ACCESS ASSESSMENT REPORT

114 Old Pittwater Road, Brookvale, NSW

Project Number: 121095

Date: 11 December 2024

Figure 1 - Threshold in the balcony on Level 1

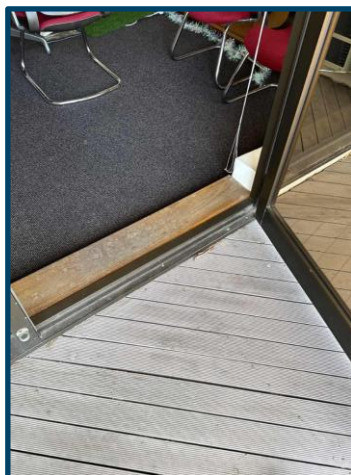
The threshold between the landing of the lift in the balcony on Level 1 and the internal space must be removed to provide a flat surface between the two areas so people with disability can enter the building from the lift and enter the lift from the building.
